Planning Commission Agenda  
November 19, 2024  
7:00 PM

**THE MATTER OF THE AKINS TRAILER SALES MINOR PARTITION (LU460-2024)**

**APPLICANT:** Udell Engineering & Land Surveying, LLC on behalf of the  
Lost Cattle Company, LLC/Thad Adkins

**LOCATION:** 640 N. 3<sup>rd</sup> St., 15S-04W-09 Tax Lot No. 1300

A. Tentative Partition Plat

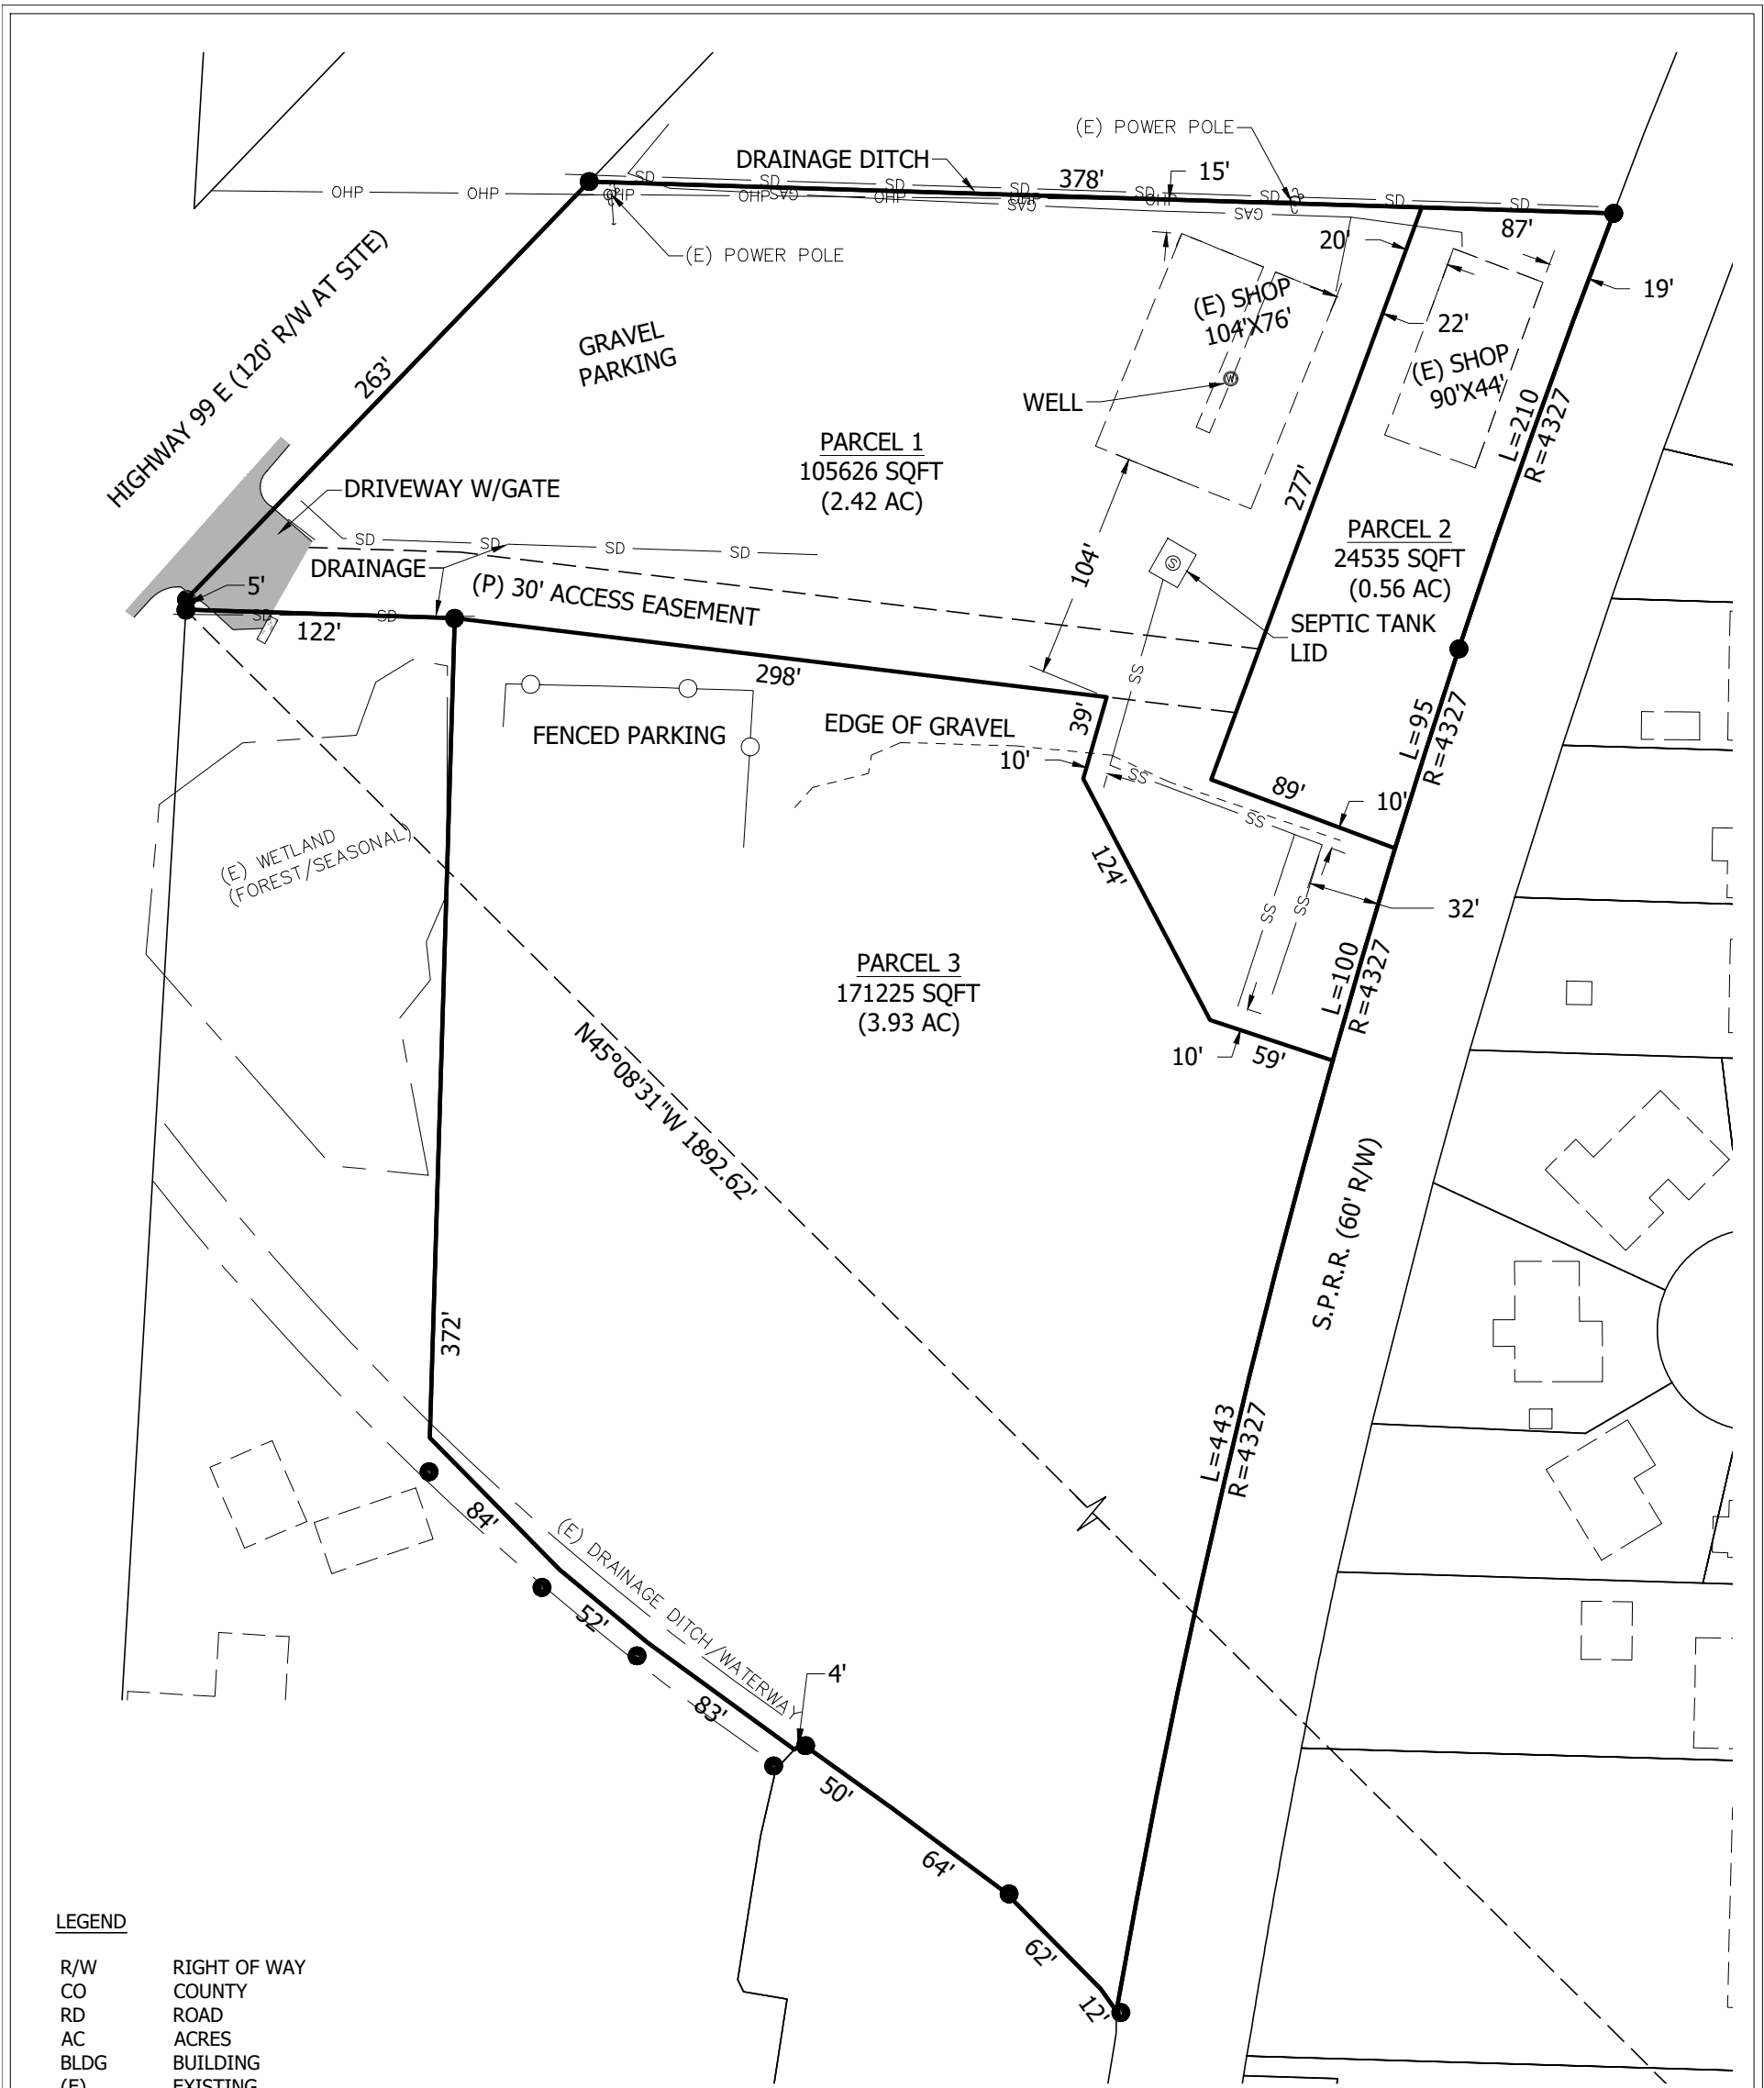
**DISCUSSION:** There are no proposed streets for this minor partition request, and all lots have access from Hwy 99E, which is accessed by an existing 30'x50' driveway that has been paved. The 'parking area' shown in proposed parcel 1 is existing based on a previous site plan, and is approximately 41,340 sq. ft. Because this is an existing use of the property, and there are no changes or development being proposed in this minor partition request, there is no requirement to have a parking lot plan, or pedestrian walkway at this time. Because the commercial business is for utility trailers, the existing plan already compensates for longer trailers, and doesn't interfere with existing loading/unloading zones.

The fenced lot located on proposed parcel 3 is also an existing lot, approved by the original site plan. It is under 40,000 sq. ft., but it is further from the warehouses. Unless there is future development, there are no changes needed for this parking area.

**DISCUSSION:** The applicant has stated that an easement is a legal right to use another property owner's property for a limited use, and because the proposed parcels are planned on being held in common ownership, its suggested that it be added if Parcels No. 2 and No. 3 undergo a future ownership transfer. The proposed private 30' wide access lane meets the minimum 25' wide requirement, plus the 5' wide pedestrian walkway that is also required. The design of the access easement must be capable of holding a 75,000 lb. emergency vehicle. The 5' pedestrian walkway must be marked in paint. The access easement shall be recorded on the final plat, and it is acceptable to have the maintenance agreement recorded when any of the parcels are sold in the future. The access easement must be paved within six months from the date of the final plat being recorded.

**Condition No. 4: Access Easement: On the Final Plat, the applicant must provide for a 30' wide access easement. The driveway/access easement shall allow joint use of and cross access between adjacent properties. It must be designed to support a 75,000 lb. emergency vehicle and must have a 5' pedestrian walkway marked in paint. The pavement of the access easement, and painting of the pedestrian walkway is required within six months from the date of the final plat being recorded.**
